RECEIPT DATE: 3/23/17 **ONSITE SEWAGE DISPOSAL SYSTEM**

APPROVAL DATE: 7/25/17 **PERMIT: CONSTRUCTION**

PROPERTY ADDRESS: 2037 Drovers Lane

SUBDIVISION: Vista Ridge LOT: 17 TAX ID: 04-595482

PRE-CONSTRUCTION:

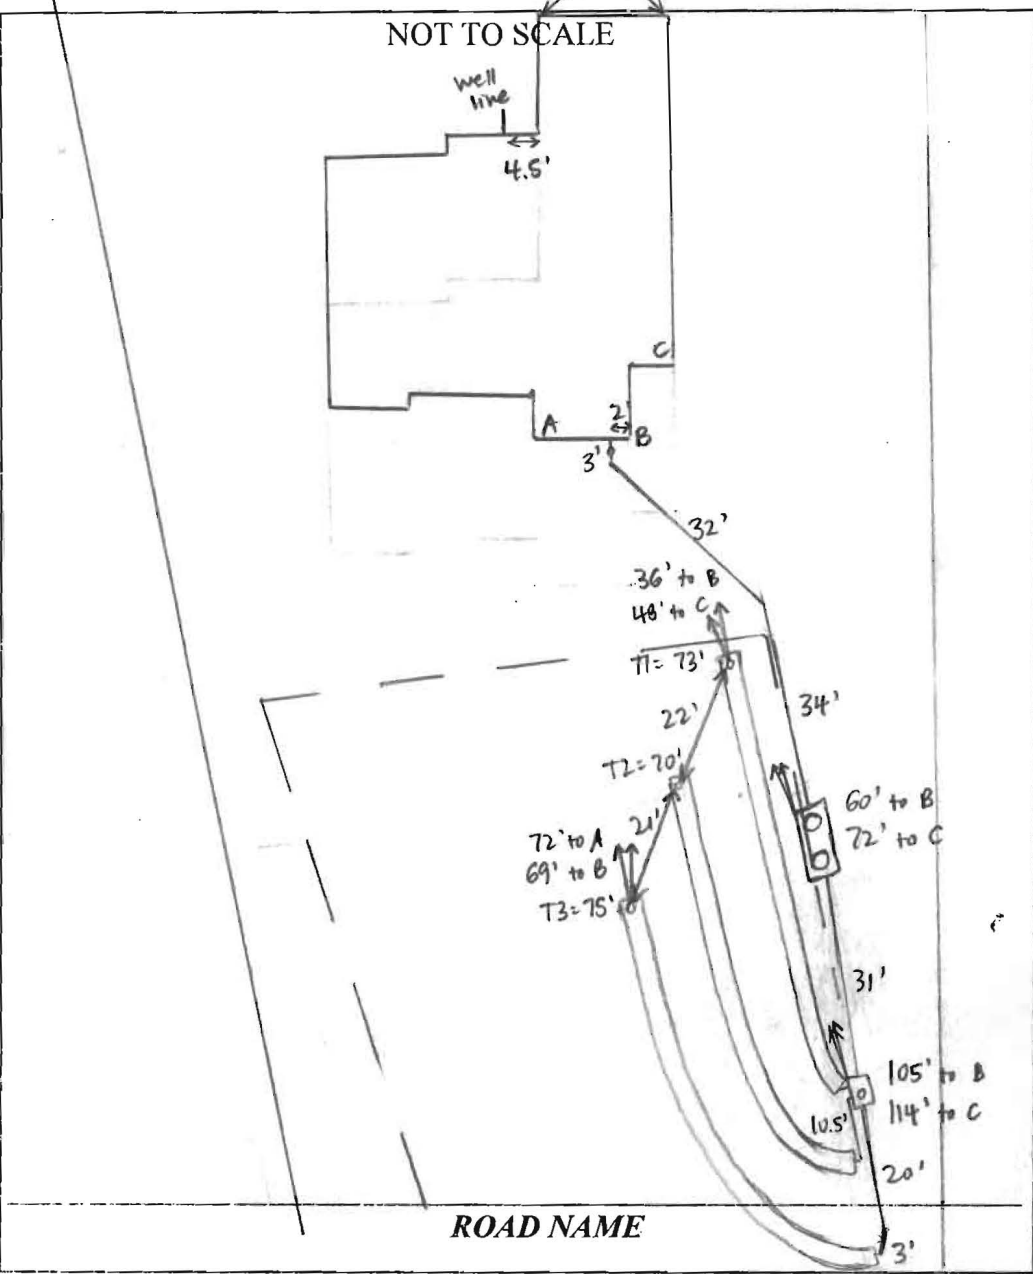
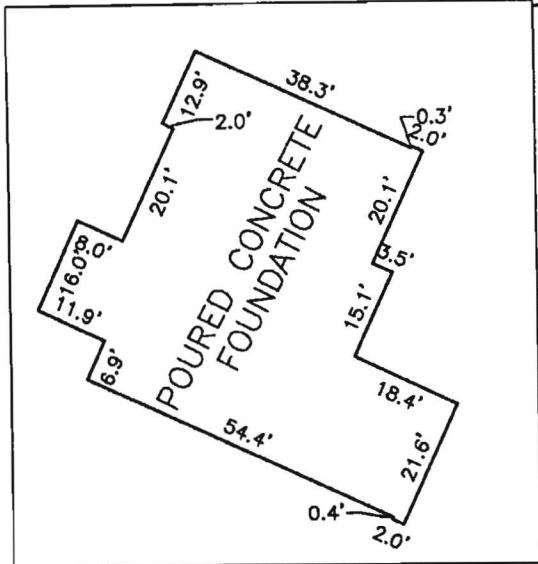
3/28/17 Met Fogle's on site for layout. All SDA corner stakes present. Shot contour + laid out 3-70' trenches. Sewer line comes out under footer - will not make fall to tank with  $\leq 3'$  cover. Builder will have sewer line hung in basement. Also spoke with builder about moving tank outside SE corner of SDA - okay to move. Fogle's may install trenches but no tank install until sewer line is hung. (S) 7/12/17 on site for tank layout. SDA + area around overgrown - must clear before layout. Plumbing in basement now hung sewer. May

need to re-layout trenches if some flags are missing. (S) 7/13/17 Area cleared + flags from 3/28 trench layout still present. Fogle's will set tank in area shown on plan, somewhat in upper SDA to save trees. Shift trenches down a few feet to keep 5' from edge of tank to trench. (S) 7/14/17 Tank set, line run from house to tank but house connection not made. T1 installed + left open @ ends, T2 finished + left open for inspection. Starts of trenches not as laid out + per plan - Fogle's says they shot contour + beginning of trenches wrapped around. Not using laser to dig, no laser on site. Used transit to check contour @ start + 15' in - within 2", depths 8', 7.5', respectively. [See pg. 2]

**WALL CHECK**

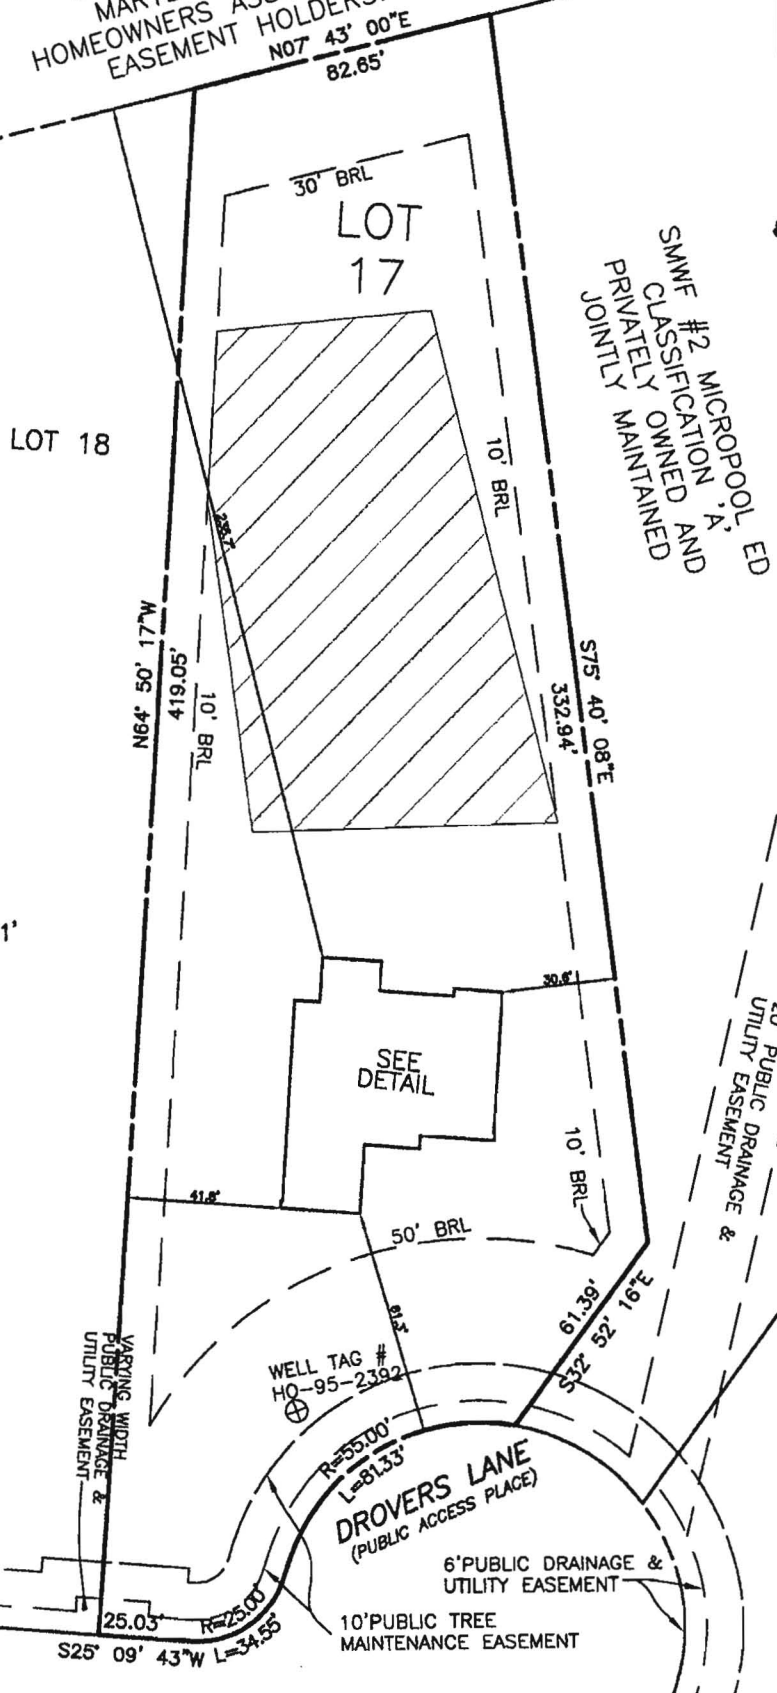
3/23/17 - wall  
 check okay  
 H.O.

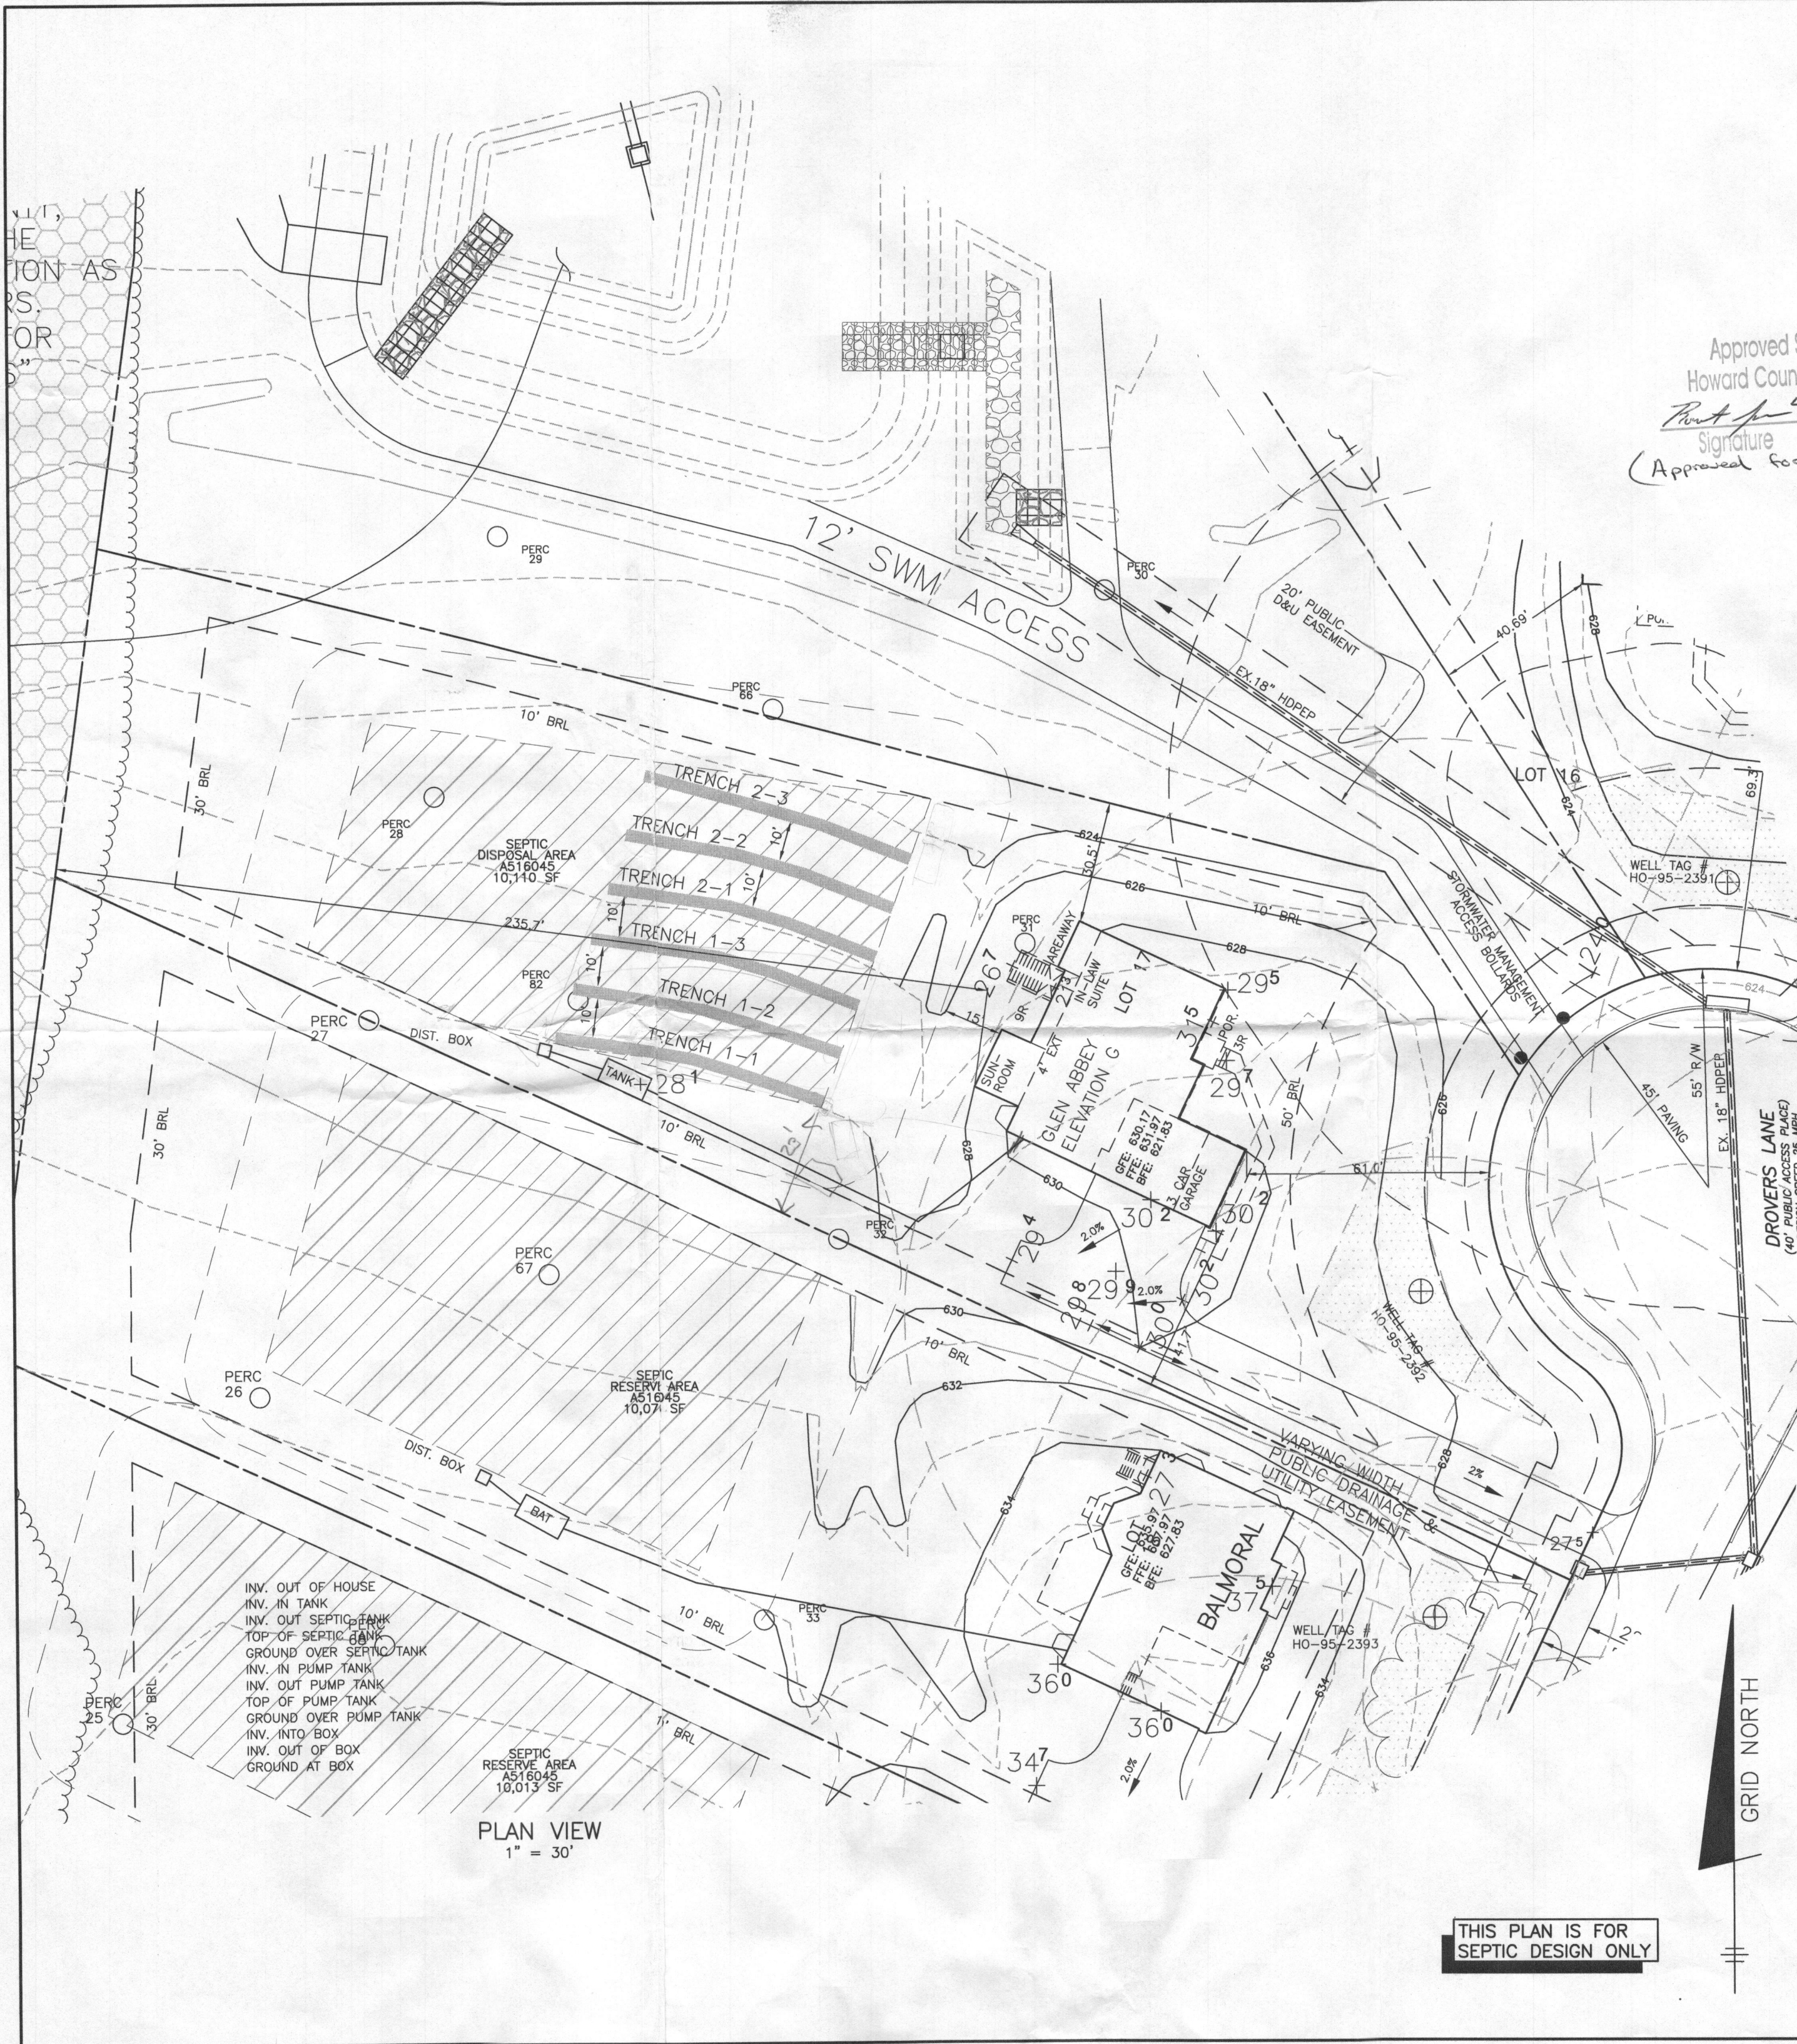
On the OSDS plans for Vista Ridge Lots 11, 13 & 17 (2038, 2046, 2037 Drovers Lane) I would like to red line the note: "The maximum earth cover over the tank is 3 feet. Greater earth cover will require a heavy load bearing tank". Would you be ok with this?

Robert, That note sounds fine. Thanks, John

- 15. The maximum earth cover over the tank is 3ft. Greater earth cover will require a heavy load bearing tank.*
